**ORDINANCE A**

(Enacting the Land Use Management Ordinance Text Amendment)

**AN ORDINANCE AMENDING SECTION 3.11 OF THE CHAPEL HILL LAND USE MANAGEMENT ORDINANCE TO UPDATE STANDARDS FOR BUILDING MASSING IN THE BLUE HILL DISTRICT (2020-##-##/O-#)**

**Section 3.11.2.3 Walkable Residential (WR-3 and WR-7) Subsection 3. Mass** is hereby revised to read as follows:

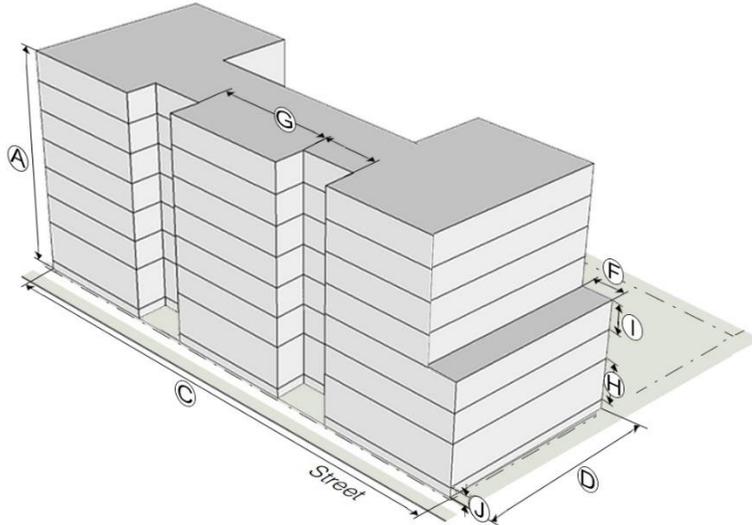
[The diagram above is revised so that labels correspond with items A, C, D, F, G, H, I and J in the associated table, as revised (note that no labels are provided for B and E)]

<b>Building Height</b>		
(A)	Building height (max)	
	- WR-7	7 stories, not to exceed 90'
	- WR-3	3 stories, not to exceed 45'
(B)	Building height for principal structures (min)	2 stories*
<b>Building Footprint and Aggregation</b>		
	<b><u>WR-3</u></b>	
(C)	- <b><u>Maximum width</u></b>	<b><u>220'</u></b>
(D)	- <b><u>Maximum depth</u></b>	<b><u>130'</u></b>
	- <b><u>One additional secondary wing allowed at:</u></b>	<b><u>75' width x 100' depth</u></b>
	<b><u>WR-7, If wrapping structured parking on at least two sides:</u></b>	
(C)	- <b><u>Maximum width</u></b>	<b><u>330'</u></b>
(D)	- <b><u>Maximum depth</u></b>	<b><u>200'</u></b>
	- <b><u>One additional secondary wing allowed at:</u></b>	<b><u>75' width x 100' depth</u></b>
	<b><u>WR-7, If not wrapping structured parking:</u></b>	
	- <b><u>Option 1 Maximum width and depth:</u></b>	<b><u>330' x 120'</u></b>

- <b><u>Option 2 Maximum width and depth:</u></b>	<b><u>275' x 210'</u></b>
	- <b><u>One additional secondary wing (for either option) allowed at:</u></b>	<b><u>75' width x 100' depth</u></b>
	<b><u>For Structured Parking:</u></b>

- <b><u>Maximum footprint dimensions:</u></b>	<b><u>230' width x 180' depth</u></b>
	<b><u>Minimum building separation when in aggregate multiple buildings placed in proximity would otherwise exceed the above criteria (see Pedestrian Connectivity)</u></b>	<b><u>30' such that no grouping of buildings exceeds the maximum widths and depths as noted in this section</u></b>
<b>Mass Variation</b>		
<b><u>ⒸⒺ</u></b>	Average floor plate area (max <b><u>as percent of ground story floor plate area</u></b> ) above 3 <sup>rd</sup> floor

- <b><u>Second and Third stories</u></b>	<b><u>Not Applicable</u></b>
	- <b><u>Fourth story</u></b>	<b><u>100% for a 4 story building; Otherwise, 80%</u></b>

- <b><u>Fifth story and above</u></b>	<b><u>70% of floor plate area of ground floor, with no floor plate exceeding 80% of ground floor area**</u></b>
	- 3 story buildings or less

- 4 story buildings or greater	70% of floor plate area of third floor, with no floor plate exceeding 80% of third floor area**
	Buildings 4 stories or greater shall meet either the step back or module offset standard below	
<b><u>ⒹⒻ</u></b>	Building step back above 2 <sup>nd</sup> or 3 <sup>rd</sup> floor (min)	10' step back above 2 <sup>nd</sup> or 3 <sup>rd</sup> floor
<b><u>ⒺⒼ</u></b>	Module offset

- Module width (max)	80'
	- Depth of offset (min)	6'
	- Width of offset (min)	12'
<b>Story Height</b>		
<b><u>ⒺⒻ</u></b>	Ground story height, floor to ceiling (min)	9'
<b><u>ⒼⒿ</u></b>	Upper story height, floor to ceiling (min)	9'
<b><u>ⒻⒿ</u> Ground Floor Elevation</b>		
	Ground floor elevation (min/max)	2'/4'

**Section 3.11.2.4. Walkable Mixed Use (WX-5 and WX-7), Subsection 3. Mass** is hereby revised to read as follows:

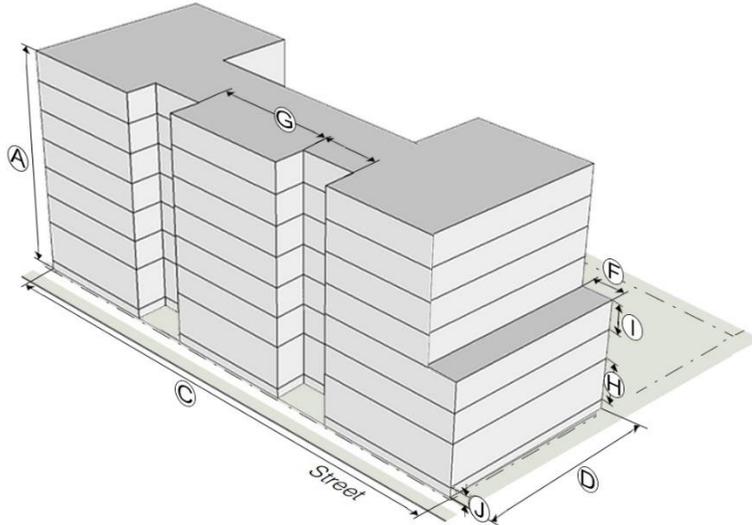
[The diagram above is revised so that labels correspond with items A, C, D, F, G, H, I and J in the associated table, as revised (note that no labels are provided for B and E)]

<b>Building Height</b>		
Ⓐ	Building height (max)	
	- WX-7	7 stories, not to exceed 90'
	- WX-5	5 stories, not to exceed 60'
Ⓑ	Building height for principal structures (min)	2 stories*
<b>Building Footprint and Aggregation</b>		
	<b><u>If wrapping structured parking on at least two sides:</u></b>	
Ⓒ	- <b><u>Maximum width</u></b>	<b><u>330'</u></b>
Ⓓ	- <b><u>Maximum depth</u></b>	<b><u>200'</u></b>

- <b><u>One additional secondary wing allowed at:</u></b>	<b><u>75' width x 100' depth</u></b>
	<b><u>If not wrapping structured parking:</u></b>	
	- <b><u>Option 1 Maximum width and depth:</u></b>	<b><u>330' x 120'</u></b>

- <b><u>Option 2 Maximum width and depth:</u></b>	<b><u>275' x 210'</u></b>
	- <b><u>One additional secondary wing (for either option) allowed at:</u></b>	<b><u>75' width x 100' depth</u></b>
	<b><u>For Structured Parking:</u></b>

- <b><u>Maximum footprint dimensions:</u></b>	<b><u>230' width x 180' depth</u></b>

<b>Minimum building separation when in aggregate multiple buildings placed in proximity would otherwise exceed the above criteria (see Pedestrian Connectivity)</b>	<b>30' such that no grouping of buildings exceeds the maximum widths and depths as noted in this section</b>
<b>Mass Variation</b>		
ⒸⒺ	Average floor plate area (max <b>as percent of ground story floor plate area</b> ) above 3 <sup>rd</sup> floor	
	<b>- Second and Third stories</b>	<b>Not applicable</b>
	<b>- Fourth story</b>	<b>100% for a 4 story building; Otherwise, 80%</b>
	<b>- Fifth story and above</b>	<b>70% of floor plate area of ground floor, with no floor plate exceeding 80% of ground floor area**</b>

- 3 story buildings or less	
	- 4 story buildings or greater	70% of floor plate area of third floor, with no floor plate exceeding 80% of third floor area**
	Buildings 4 stories or greater shall meet either the step back or module offset standard below	
ⒹⒻ	Building step back above 2 <sup>nd</sup> or 3 <sup>rd</sup> floor (min)	10' step back above 2 <sup>nd</sup> or 3 <sup>rd</sup> floor
ⒺⒼ	Module offset

- Average module width (max)	80'
	- Depth of offset (min)	6'
	- Width of offset (min)	12'
<b>Story Height</b>		
ⒻⒽ	Ground story height, floor to ceiling (min)

- Residential	9'
	- Nonresidential	13'
ⒼⒾ	Upper story height, floor to ceiling (min)	9'
<b>ⒽⒿ Ground Floor Elevation</b>		
	- Residential (min/max)	2'/4'
	- Nonresidential (min/max)	0'/2'
